**SHUTTLE ORBITER S-BAND COMMUNICATIONS
EQUIPMENT DESIGN EVALUATION**

FINAL REPORT

Contract No. NAS 9-15514A

**Axiomatix Report No. R7901-3
January 20, 1979**

Figure 9. NASA/DOD Low Mode Triplexer Receive Filter

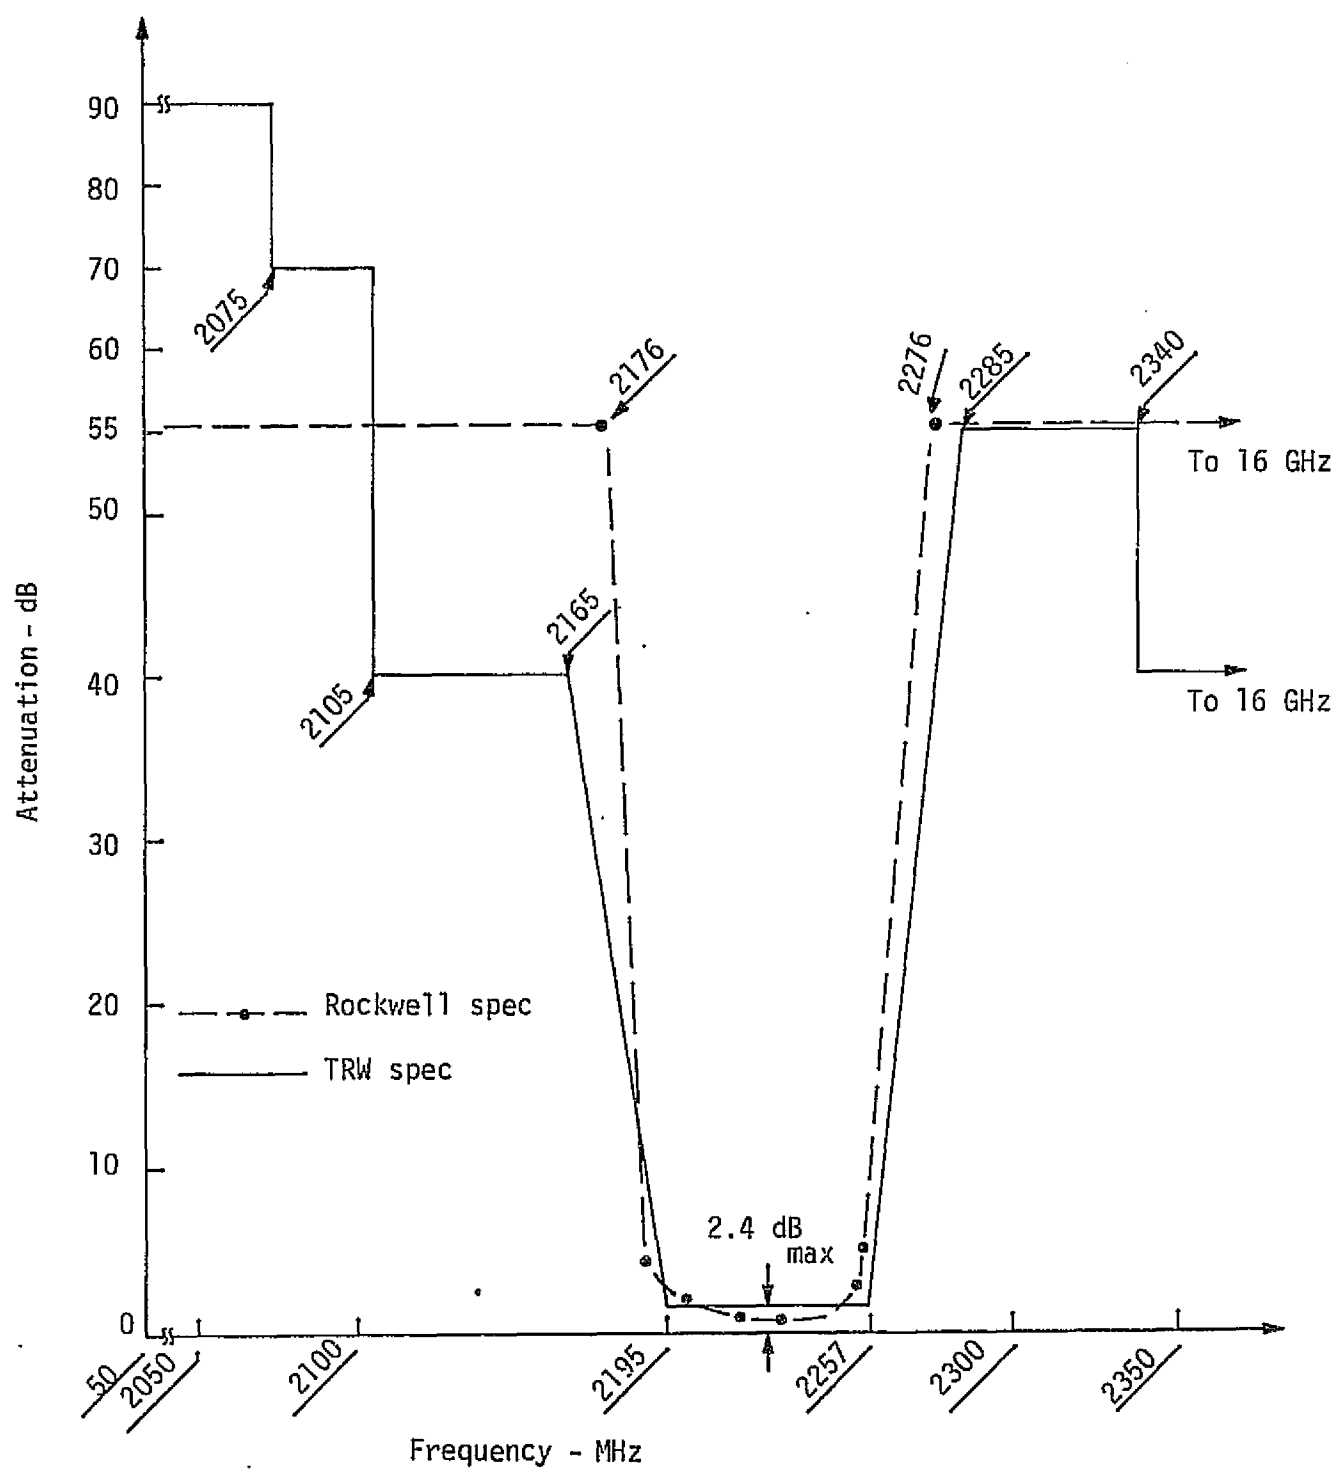
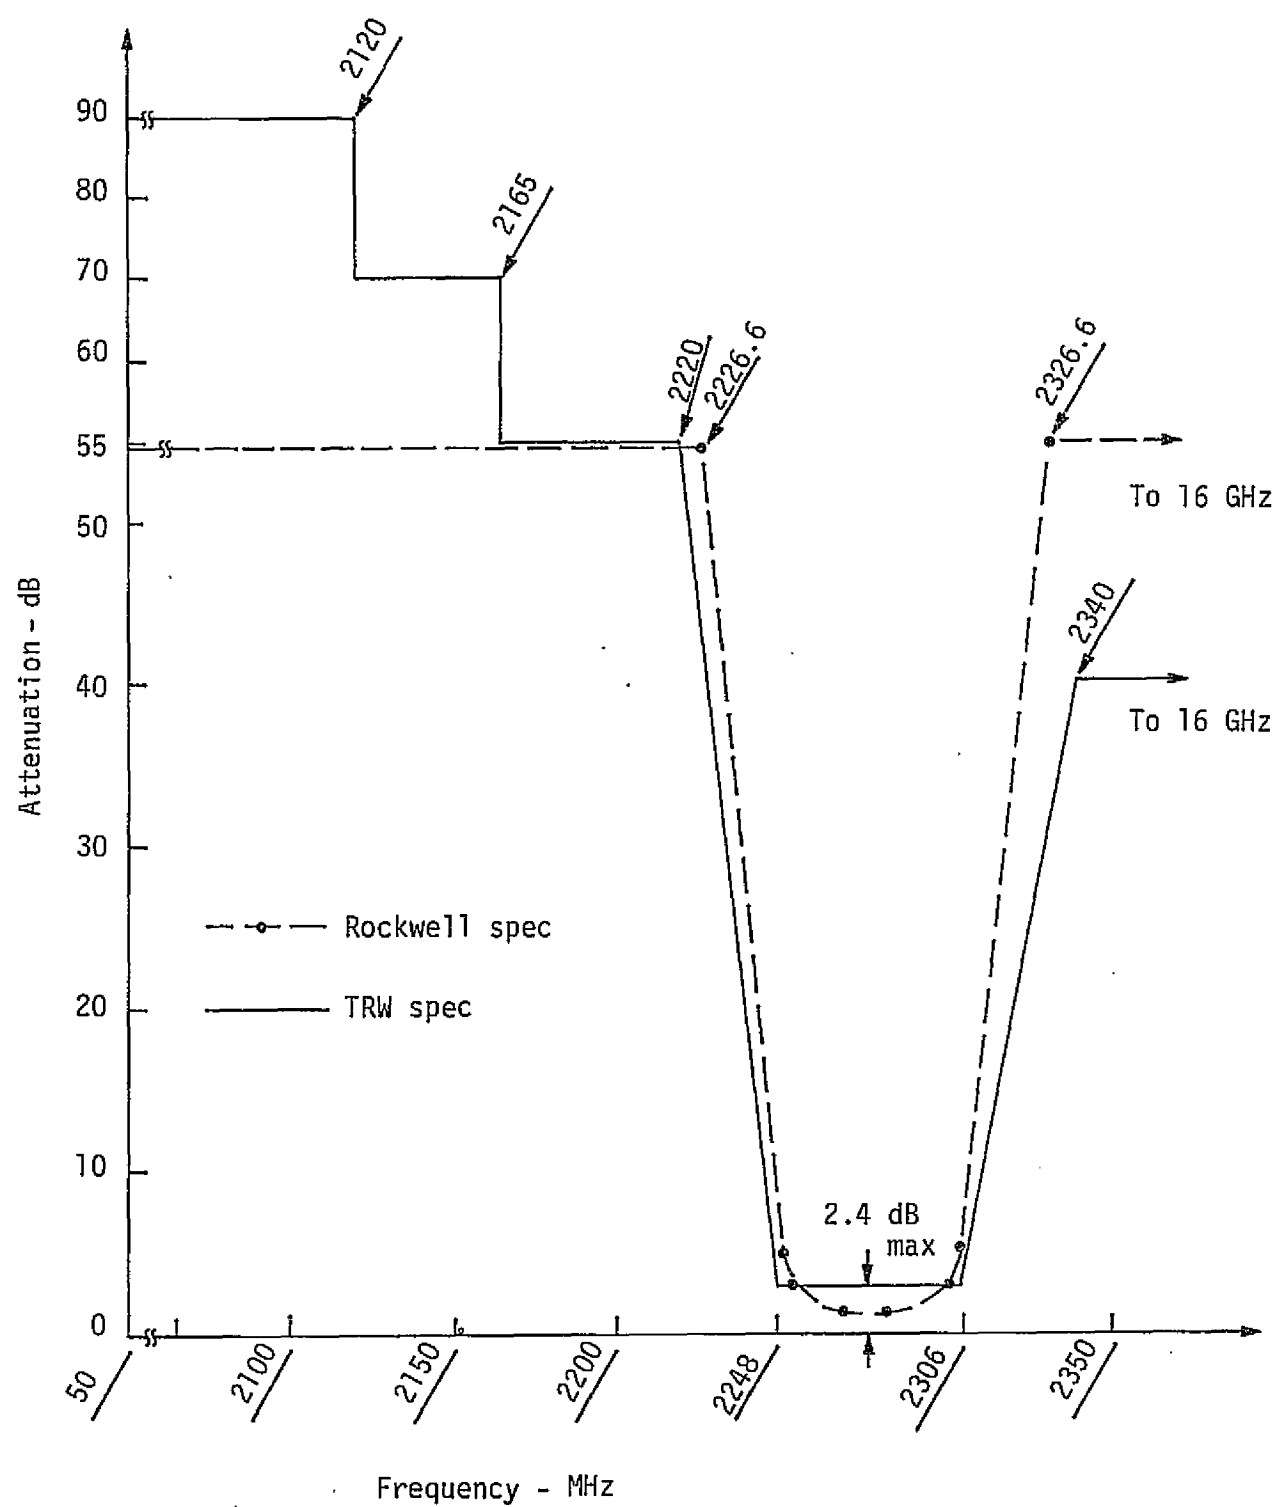
Figures 9 and 10 show, respectively, attenuation-frequency plots of the receive selectivity specification for the low and high bands of the triplexer. TRW's characteristics are indicated by solid lines, and the Rockwell specifications are superimposed as dashed lines.

A comparison of the two specifications shows that both provide 55 dB of attenuation at the critical network transmitter frequencies of 2217.5 MHz (low) and 2287.5 MHz (high). The exact rolloff characteristic, however, is not specified by TRW, thereby providing latitude for the filter configuration design. By indicating only the locations of the breakpoint frequencies, many characteristics (Butterworth, Chebyshev and elliptic function, for example) may be used to minimize in-band insertion loss and provide maximum in-band flatness.

From these plots, it can be seen that, at the expense of reduced rolloff in the noncritical frequency regions, the TRW specification provides superior attenuation over the PI receive bands. This is a good design philosophy.

An examination and comparison of the TRW and Rockwell specifications for the PI triplexer show that the TRW specification does not compromise on any critical parameters while, at the same time, it is consistent with providing flexibility for the practical design optimization of the triplexer filters.

Figure 18. PI Receiver Simplified Block Diagram With Waveforms at Different Points of CAD Channel

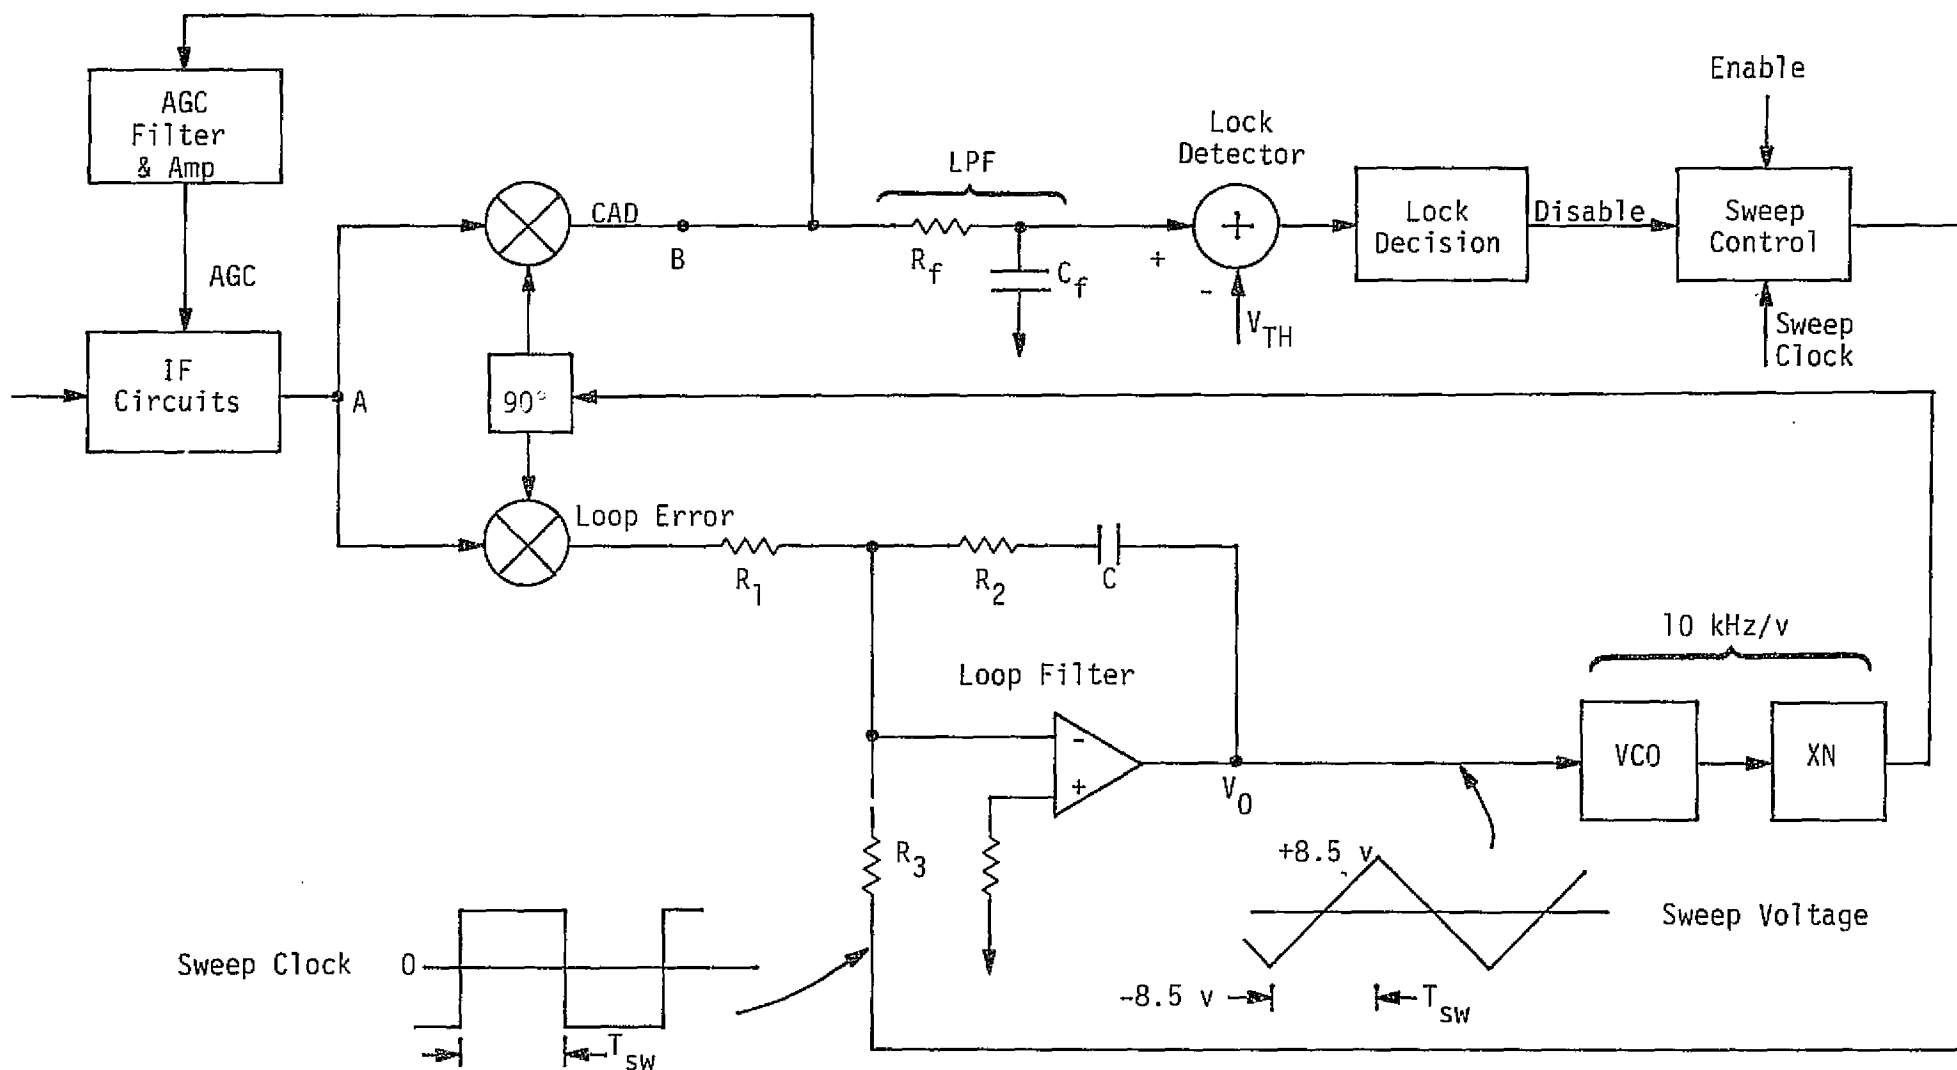
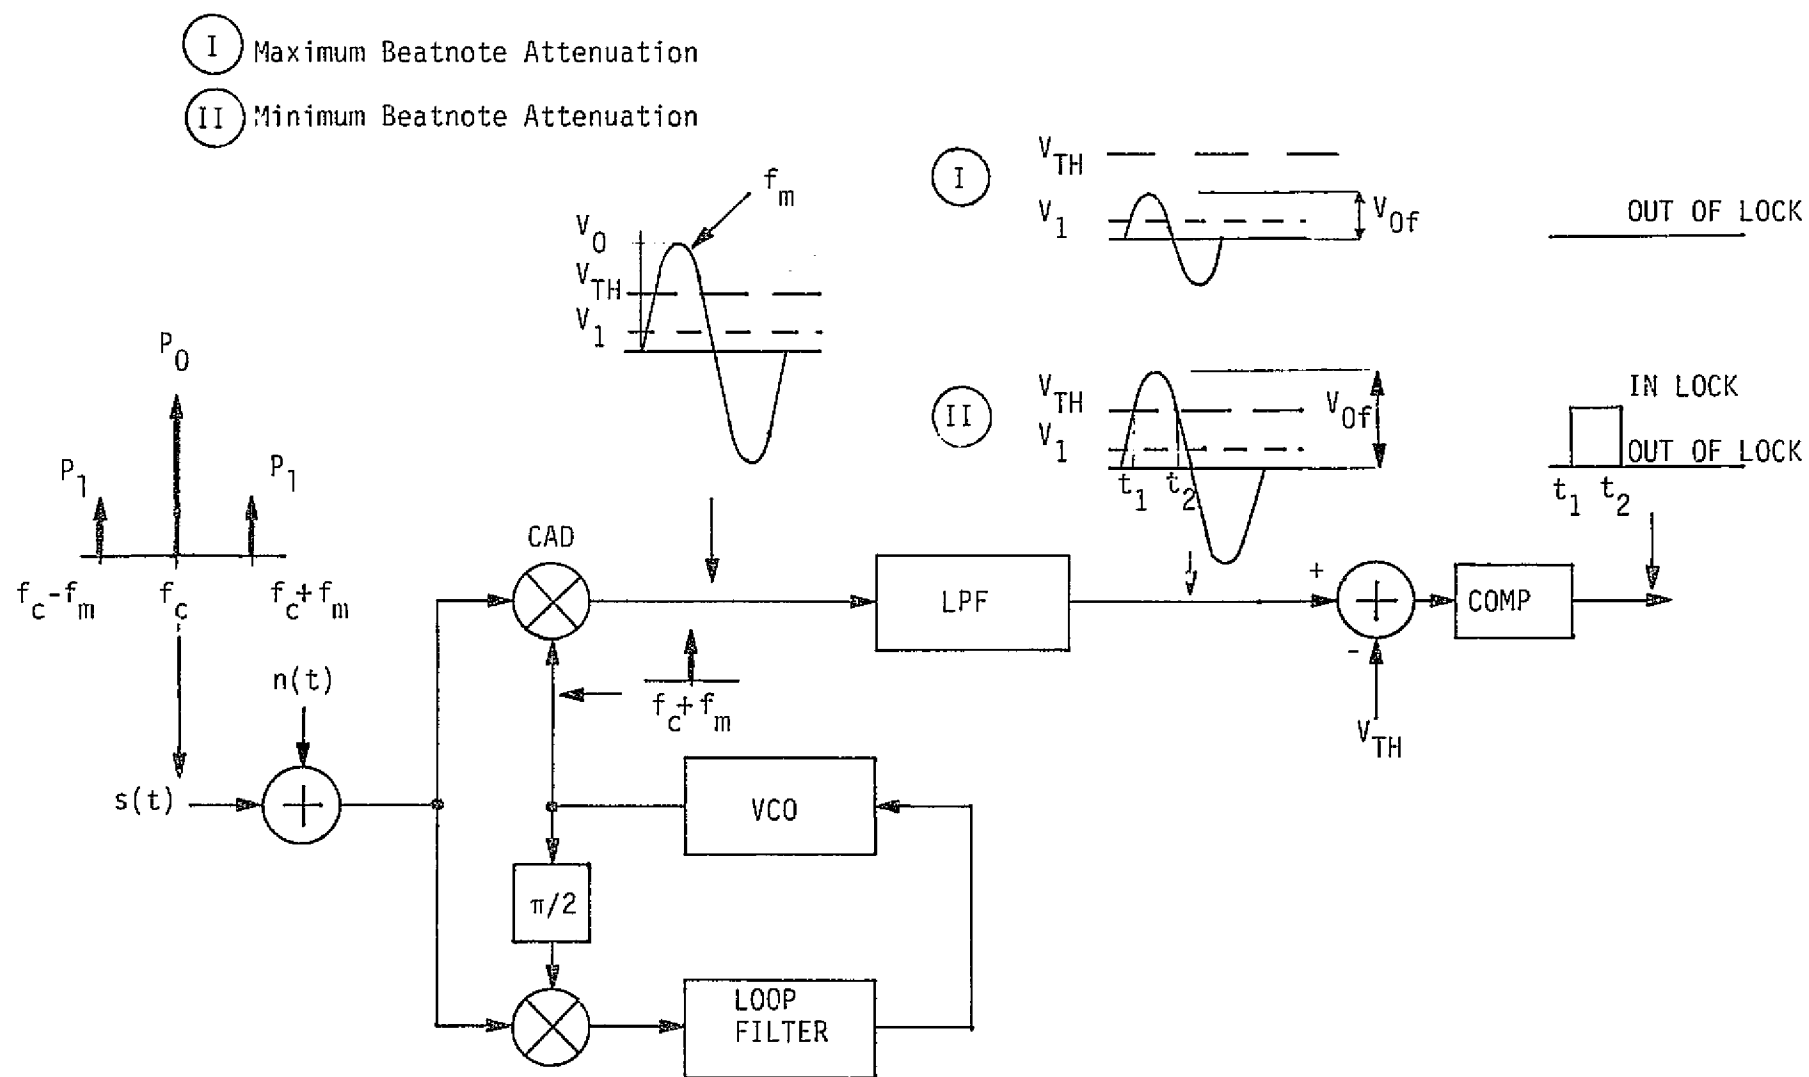
Referring to Figure 18, it can be seen from the graphical inset above the CAD that the maximum positive voltage swing of the combined direct voltage and beat note voltage will be $V_1 + V_0$, and that this can be much greater than the comparator threshold voltage, V_{TH} . However, the LPF between the CAD and comparator should have a significant attenuating effect on the beat note depending upon (a) the relationship between the beat note frequency, f_m , and the filter 3 dB frequency, f_0 , and (b) the order of the LPF. Two possible results may thus be obtained as depicted on Figure 18 following the LPF: Case I, where the beat note is sufficiently attenuated so that the threshold voltage is not exceeded and the detector indicates out-of-lock all of the time; and Case II, where the beat note is insufficiently attenuated so that the lock detector has an in-lock state for some fraction of the beat note cycle.

Clearly, only Case I is acceptable for all situations conducive to false lock*. Therefore, the designer of the lock detector must specify f_0 and the order of the LPF to meet the requirement. As an aid in making the necessary trade-offs, Axiomatix plotted the comparative LPF responses of 1st, 2nd and 3rd order Butterworth filters. The overall characteristics are shown in Figure 19, and magnified characteristics for the 1st and 3rd order filters appear in Figure 20. A number of vertical scales for the ratio of V_{0f}/V_1 are supplied as a function of the sideband to carrier power ratio, P_1/P_0 , V_{0f} being the attenuated value of V_0 .

Figure 26. Analysis Results

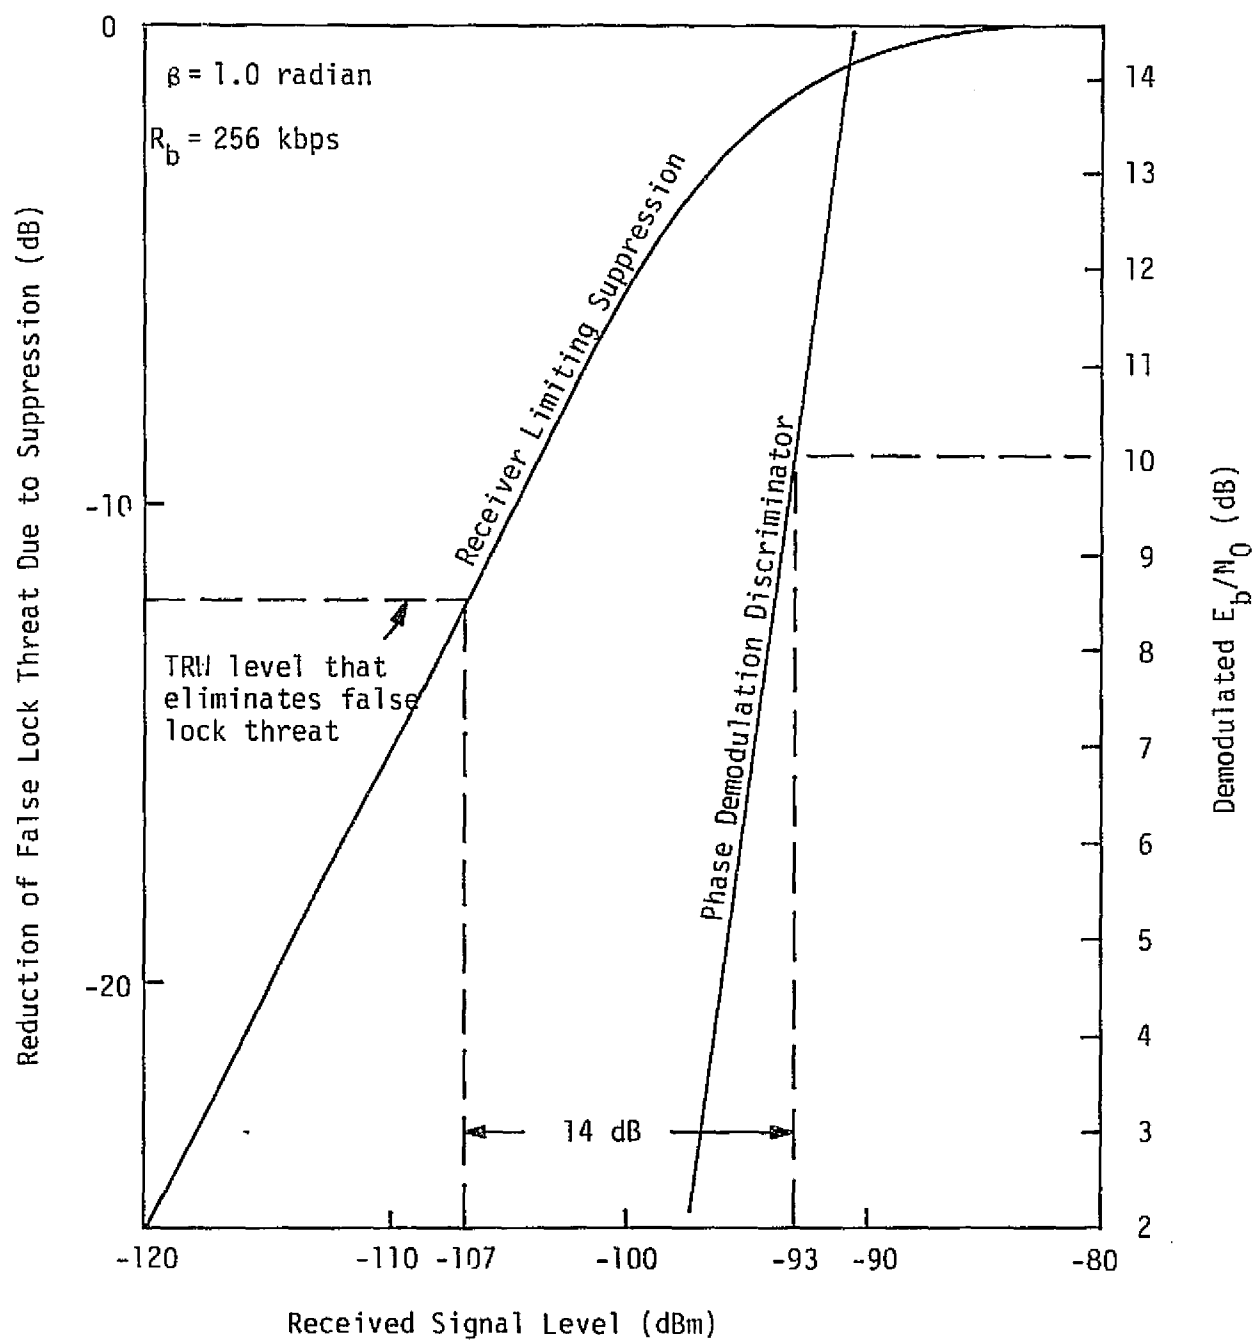
Consider an example value of $E_b/N_o = 10$ dB. Figure 26 shows that this is obtained when the received signal level is -93 dBm. Based upon the premise set forth at the end of subsection 5.3.4.1, however, this is 14 dB higher than that desired, namely, the -107 dBm received signal level for which the coherent receiver false lock threat disappears.

An interesting point of note is that, for the phase demodulator performance shown in Figure 26, the discriminator is operating in the nonimprovement region, i.e., below the knee of the curve. This may be seen from the fact that $E_b/N_o = 10$ dB corresponds to $(\text{SNR})_o = -2.9$ dB (see Figure 26). It is clear that this will always be the situation if B_i and B_o are on the order of the numbers cited for the current PI wideband channel.

From the results shown in Figure 26, it has been established that use of a noncoherent phase demodulation discriminator in place of the coherent PLL demodulator over the complete range of received signal levels for which the PLL/lock-detector circuits portend false lock will not work. This conclusion is based upon the fact that the phase demodulation
